Subject: Duke Energy Corporation  
Oconee Nuclear Station - Units 1, 2, and 3  
Docket Nos. 50-269, 50-270, and 50-287

Revisions to Topical Report DPC-NE-3003 In Support of  
Steam Generator Replacement  
Response to NRC Staff Request for Additional  
Information

Enclosed herein, please find the Duke Energy Corporation (Duke) response to the May 12, 2003 NRC staff's request for additional information concerning topical report DPC-NE-3003, Revision 1, "Mass and Energy Release and Containment Response Methodology."

### **Duke Power Response To Request For Additional Information**

(14.1 ft<sup>2</sup> Break - SG Inlet - Low Initial RCS Flow w/ M1 Pump Degradation Model)

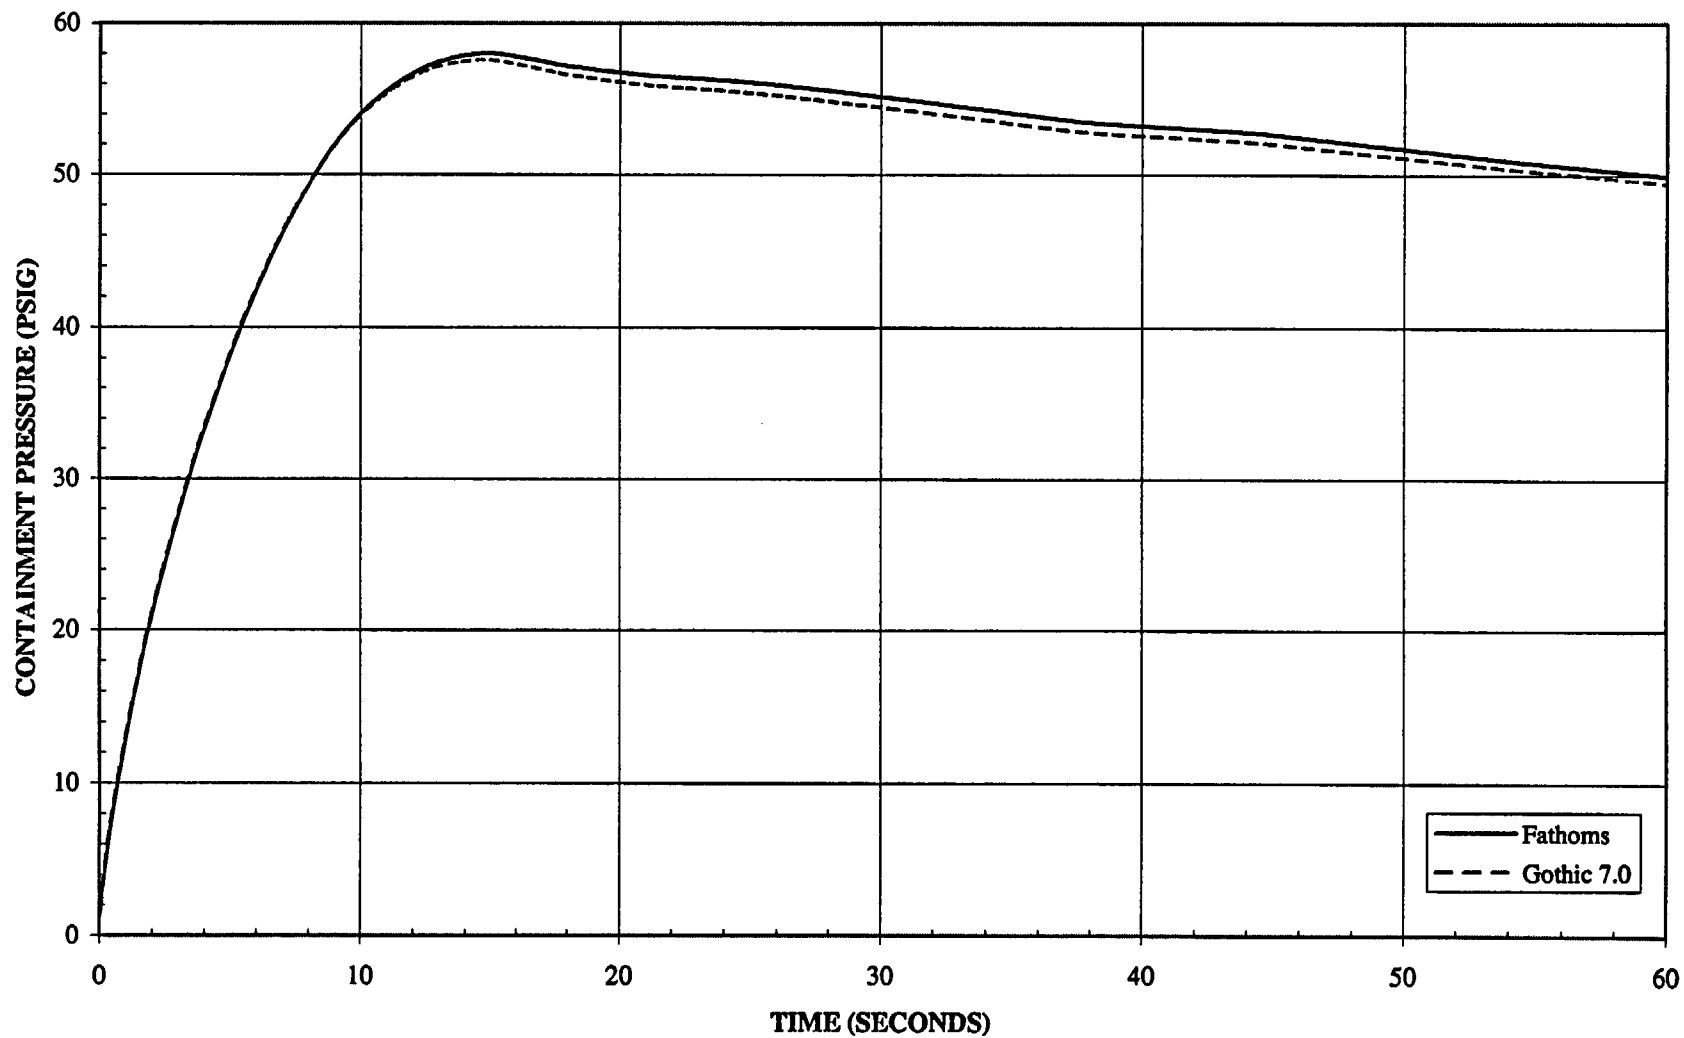
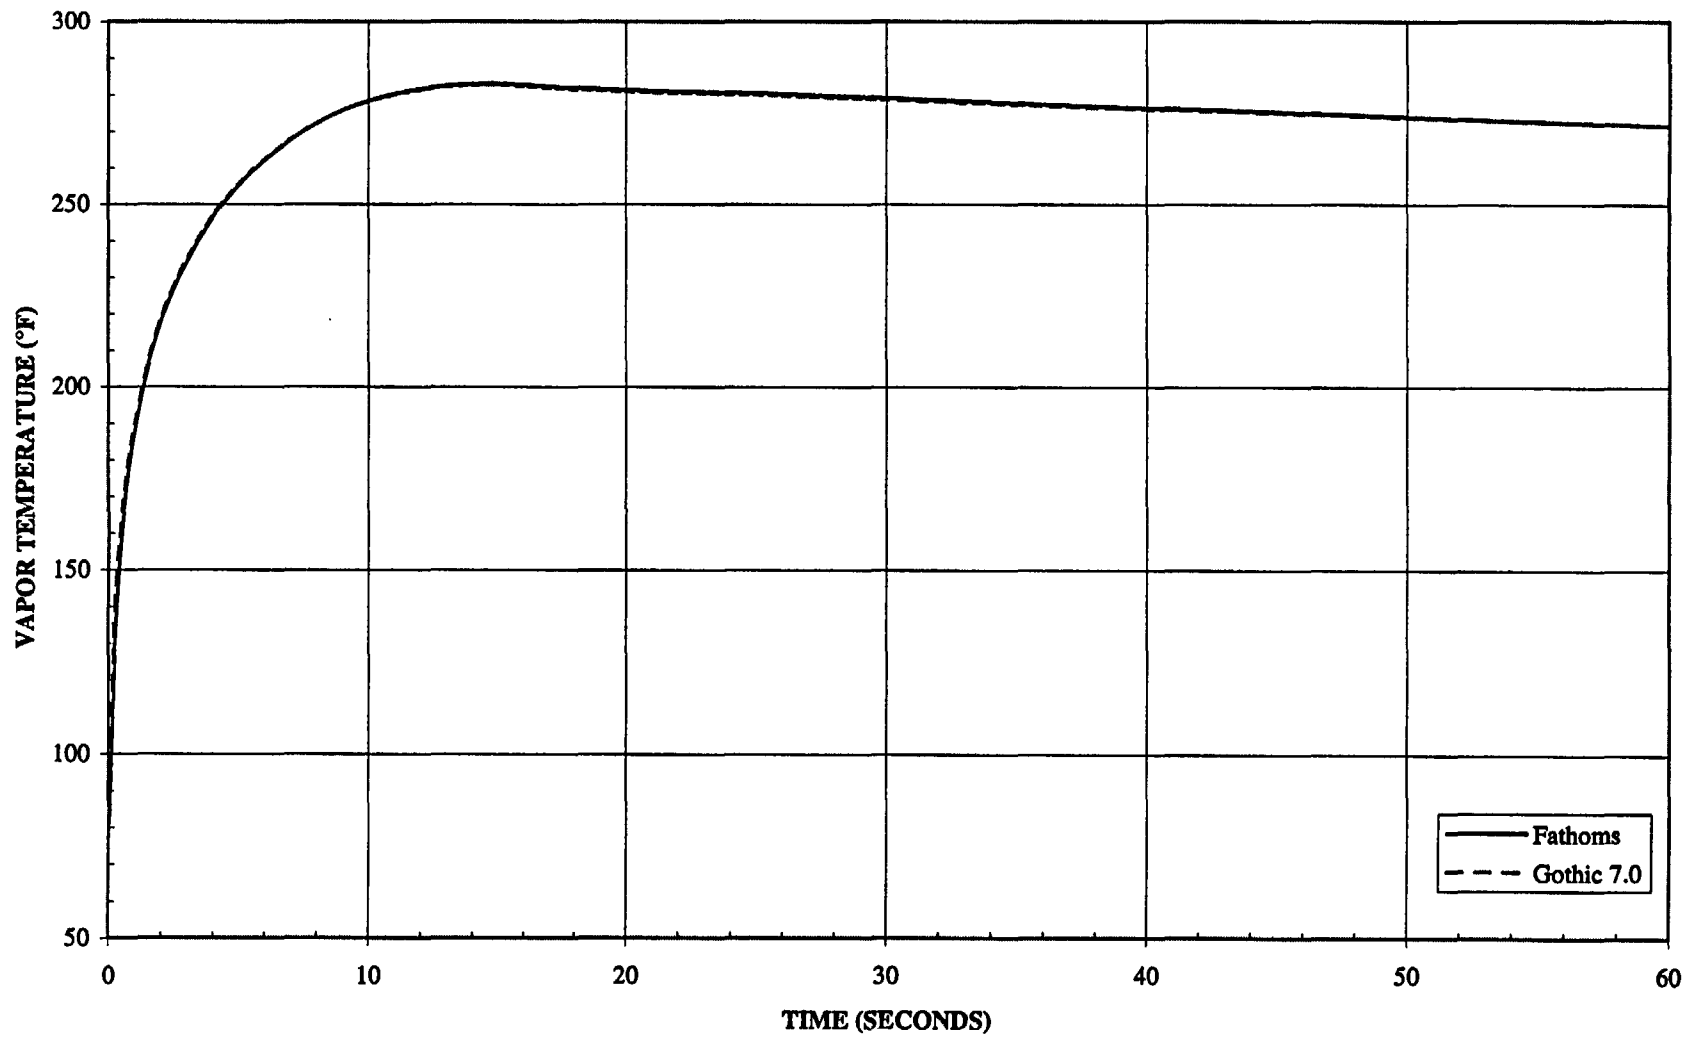
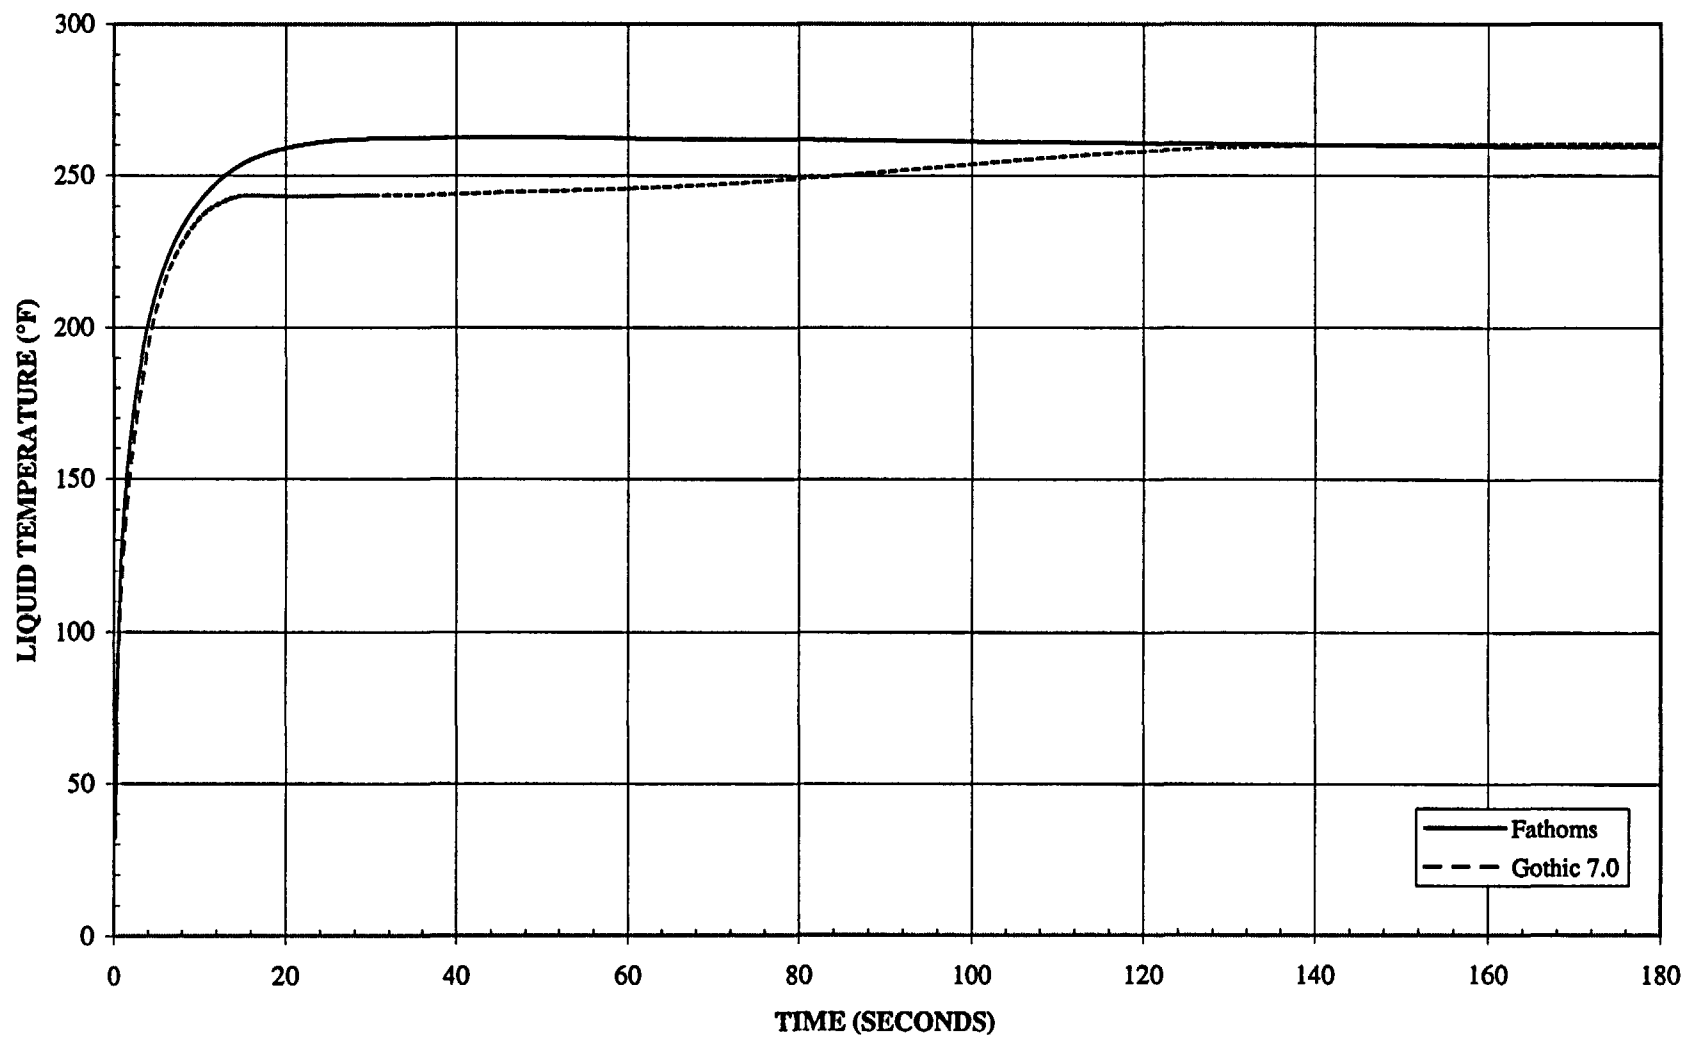
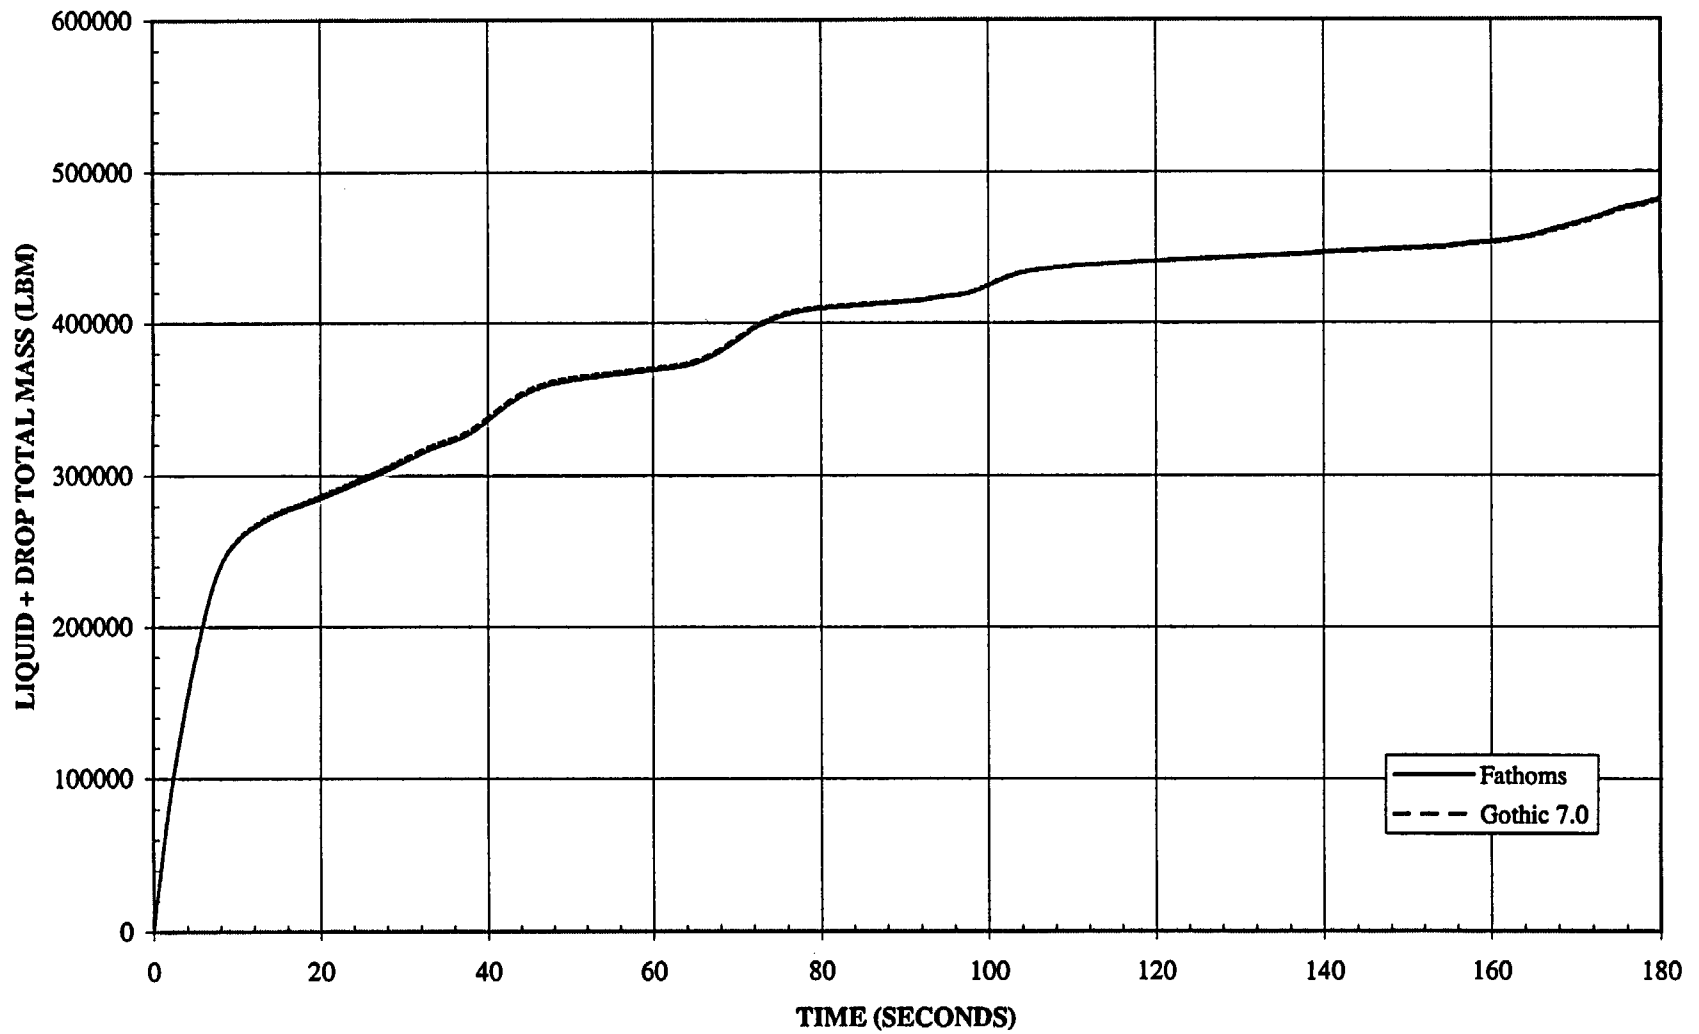
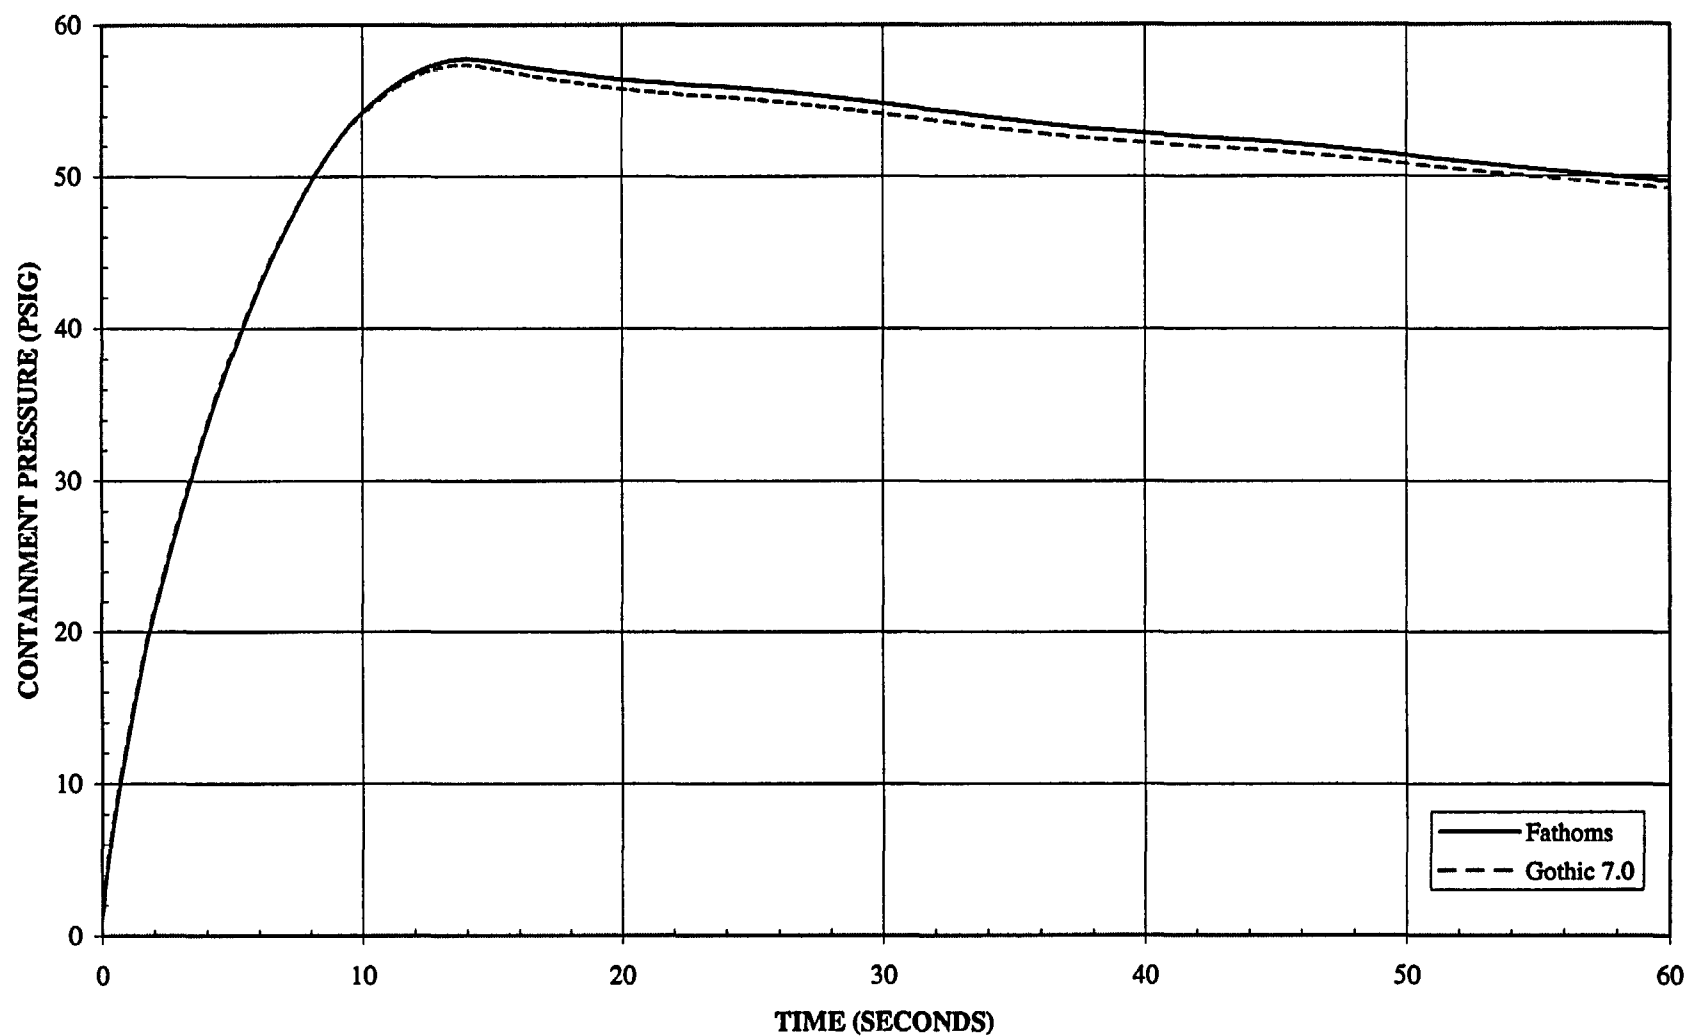
3. Please provide the results using the GOTHIC 7.0 code of peak pressure and temperature calculations for the sensitivity cases listed in Table 3.1-1 of DPC-NE-3003 in tabular and graphical form. If the results or conclusions are significantly different from those presented in DPC-NE-3003P, explain the difference.

Response: Table 3.1-1 of DPC-NE-3003 describes a spectrum of LOCA peak pressure cases including a range of break locations and sensitivity analyses for several important modeling assumptions. The staff's request is understood to focus on the difference in the predicted results from the FATHOMS and GOTHIC 7.0 code versions. Rather than show the comparison for the cases in Table 3.1-1, a different set of cases has been selected which is more focused on the current knowledge of the key sensitivity parameters. Also, the results presented are for the ROTSGs, which is the subject of Revision 1 to the topical report.

The results of the 14 code comparison analyses are shown in Table 3-1 below and in the figures that follow. In general, the pressure and vapor temperature response predictions were very similar in both magnitude and trend. GOTHIC 7.0 predictions for peak pressures and vapor temperature were slightly lower (~0.5 psig and 0.5°F). These differences are consistent with the code model differences described in the response to Question #1. Both codes predict a saturated containment atmosphere due to the large amount of drops injected. The slightly lower pressure, vapor temperature, and liquid temperature from GOTHIC 7.0 may be attributed to additional drop hold up in the atmosphere. This effectively increases the heat capacity of the atmosphere and reduces the temperature rise for a given energy addition. A comparison of the total liquid and drop masses, and liquid temperatures, show the predictions of the two codes to be essentially the same. This is consistent with the changes in the drop deposition and entrainment models discussed in Question #1. These results show that the two code versions give essentially similar results for the same break location and initial and boundary conditions.
